AGRARIAN DEVELOPMENT HOLDINGS LTD

LAND SOUTH OF THE A5, HINCKLEY

WALKING, CYCLING AND HORSE-RIDING REVIEW REPORT

project number: ADC1839			report reference: ADC1839-RP-Y
version	date	author	comments
1	13/07/2022	see team statement	review at end of preliminary design stage
2	26/01/2024	see team statement	updated review at end of preliminary design stage

Drg No:	Rev:
ADC1839-DR-693	P5

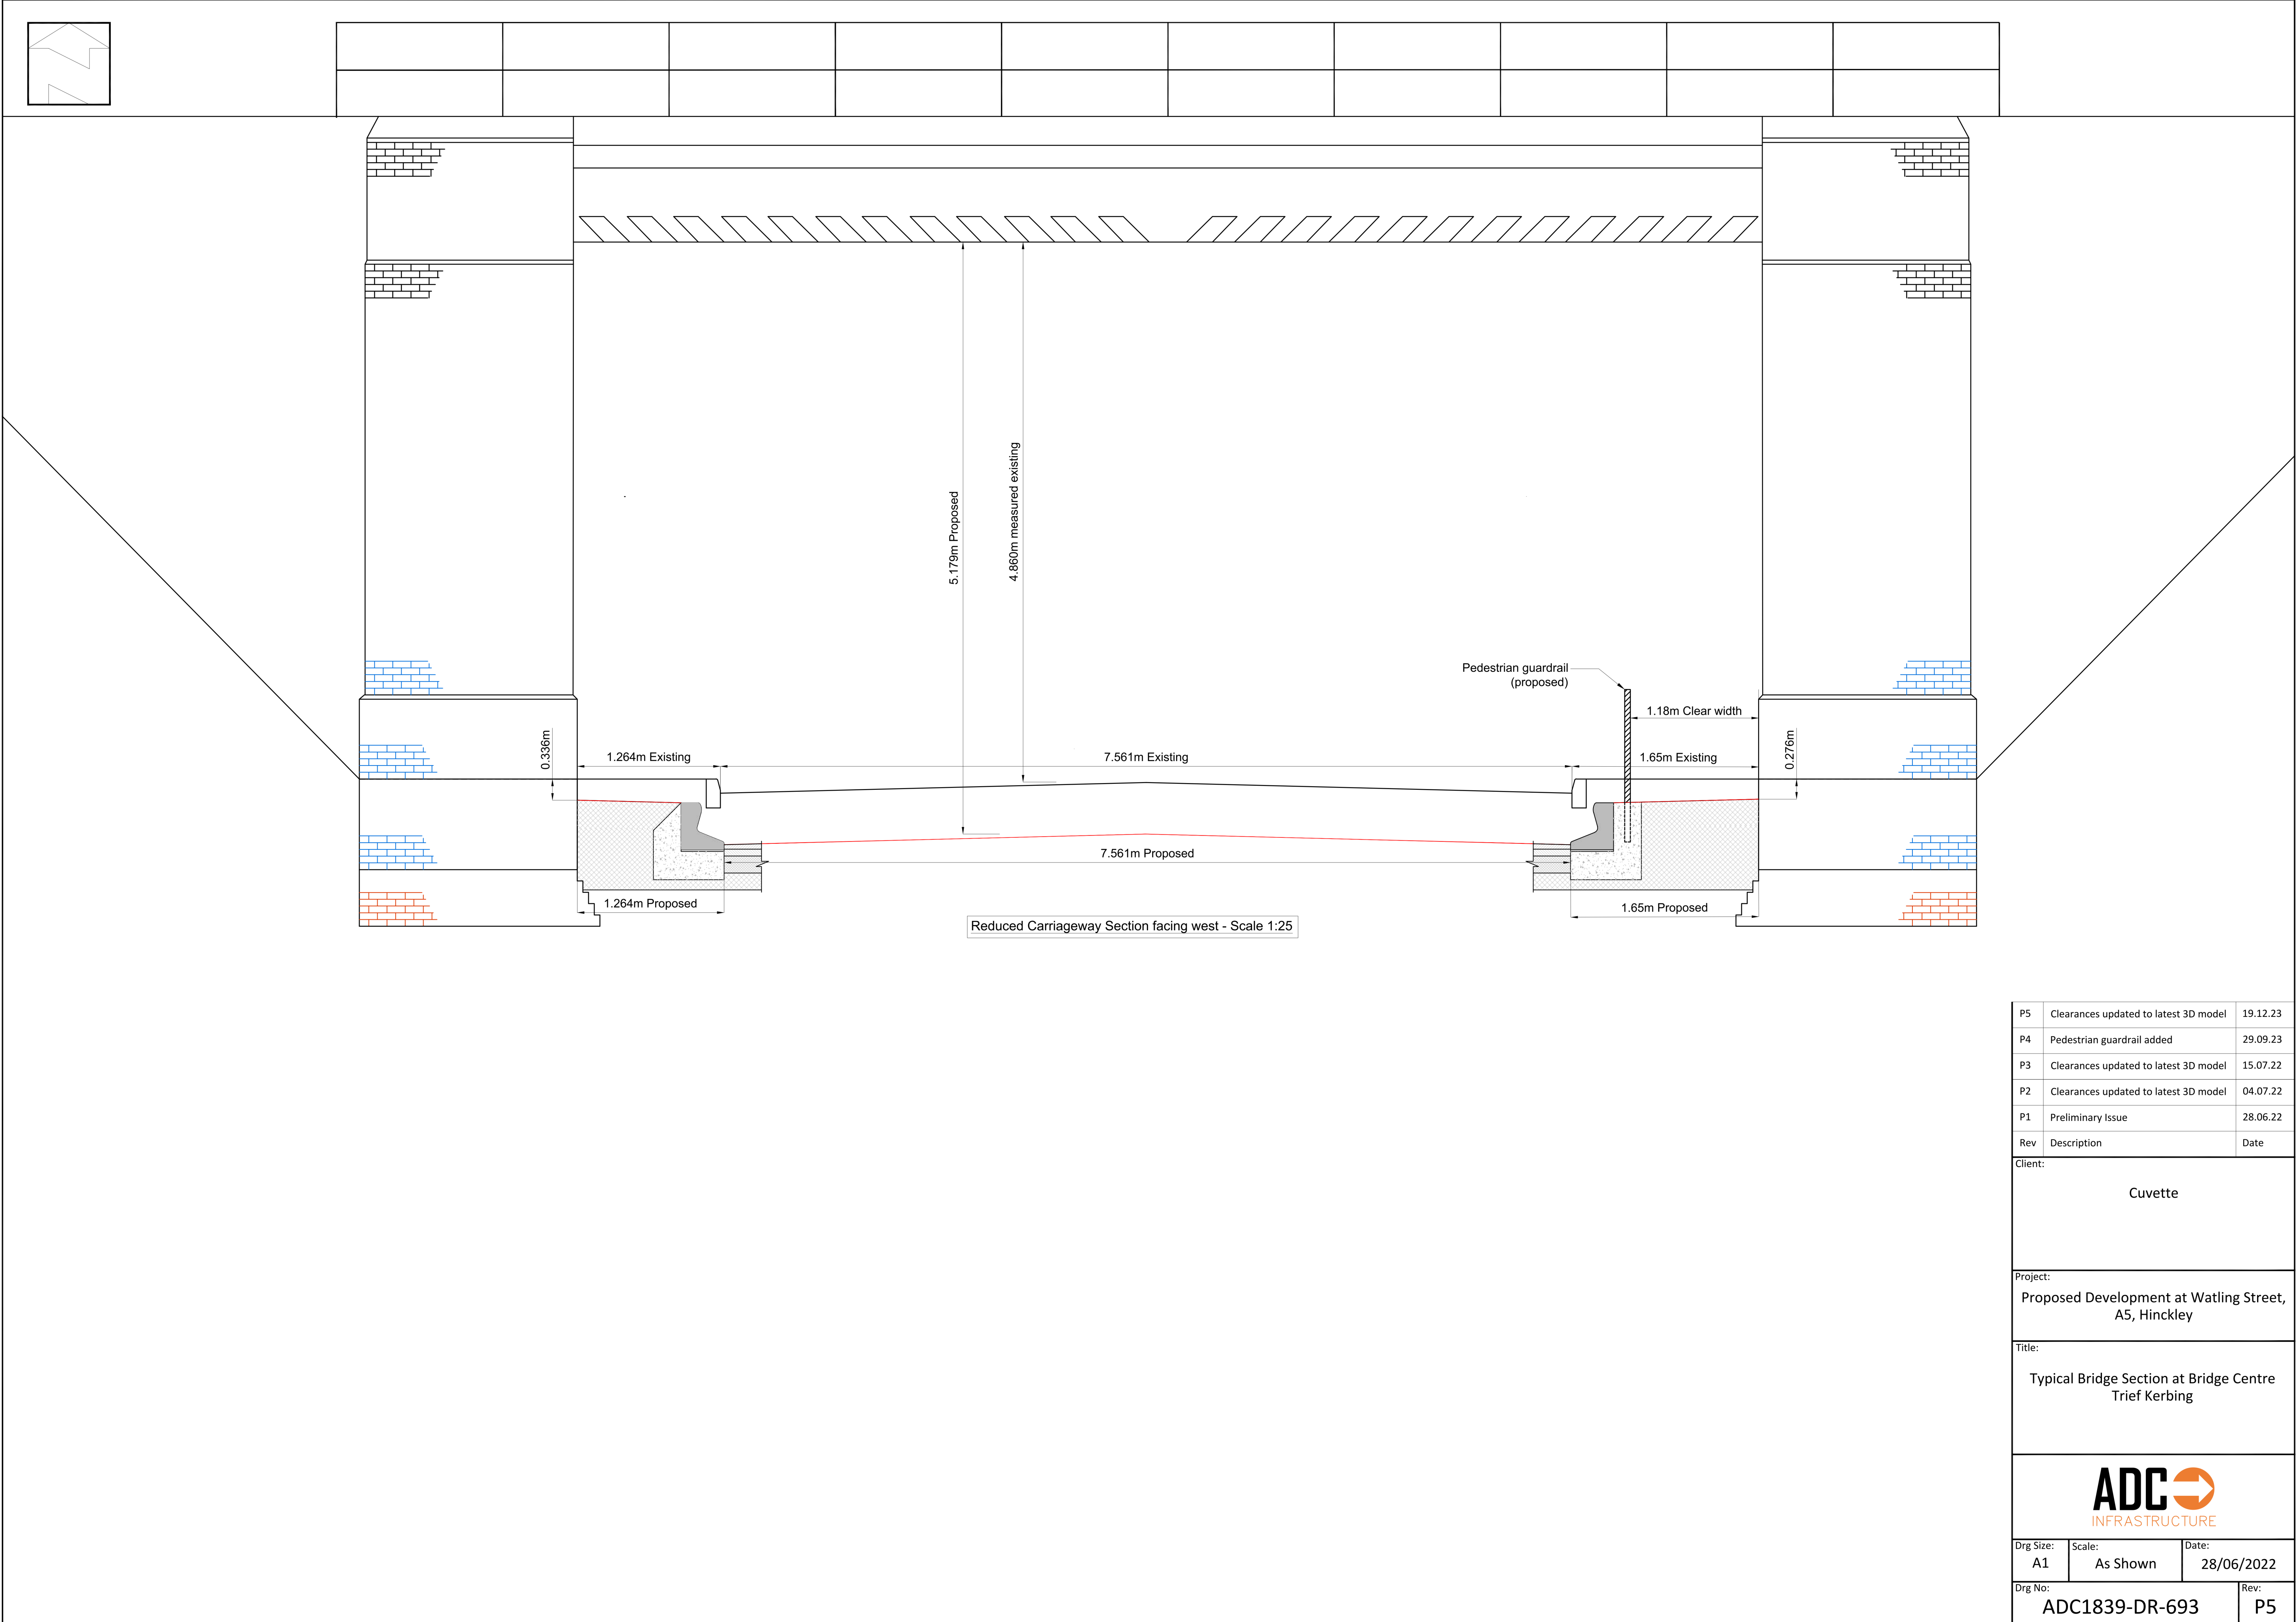
General			
Ref	Opportunity	Realised?	Review against the preliminary design
1	Consider a footway or shared footway/cycleway along the northern carriageway of the A5 Watling Street between the site access and the railway bridge, where the verge is being used by a small number of pedestrians and cyclists.	Y	Following agreement of version 1 of this WCHAR Review Report with National Highways, Opportunity 1 was further discussed with National Highways and Leicestershire County Council, in combination with the local planning authority, during meetings on 19 December 2022 and 31 January 2023. Leicestershire County Council supported the provision of a new footway alongside the A5 connecting the site access and the railway bridge, to accommodate the existing demand (as evidenced by the worn path on the highway verge and NUM surveys presented in the WCHAR Assessment Report), and potential additional demand that could be generated by the proposed development. National Highways also confirm their support for the provision of the footway subject to a Stage 1 RSA and WCHAR. In accordance with CD 143, and the 50mph speed limit for this section of the A5, a footway should provide a 1.5m separation from the carriageway and shall be an absolute minimum of 2m. Drawing ADC1839-Z01-DR-120 P02 shows provision of the footway link between the site access and the railway bridge in accordance with these requirements. There is a restricted cross section under the A5 Watling Street railway bridge. The current service margins adjacent to the A5 under the railway bridge are approximately 1.6m on the northern

side and 1.2m on the southern side. Therefore, there is insufficient space available to provide a footway in accordance with CD 143, which should provide a 1.5m separation from the carriageway and shall be an absolute minimum of 2.5m (2m + 0.5m due to the bridge abutment). As recorded in version 1 of this WCHAR Review Report, it was previously considered and discussed with National Highways whether the alignment of the A5 carriageway under the railway bridge could be altered to provide greater clearance between the carriageway edge and the bridge abutment on the northern side of the road, at the expense of reducing the clearance between carriageway and the bridge abutment on the southern side. However, this would bring the carriageway closer to the bridge abutment, which would be a further departure on an already non-compliant cross section and would introduce additional safety risks. The proposals at the railway bridge have therefore been amended to include for a short section of footway under the railway bridge. The footway does not meet the required minimum footway width or recommended separation distance from the carriageway. Drawing ADC1839-DR-693 P5 shows the proposed provision under the railway bridge, which would provide a 1.18m wide footway for an approximately 20m length, with a 0.47m separation from the carriageway. The proposals include the provision of pedestrian guard rail between the footway and the live carriageway for the section of footway beneath the railway bridge.
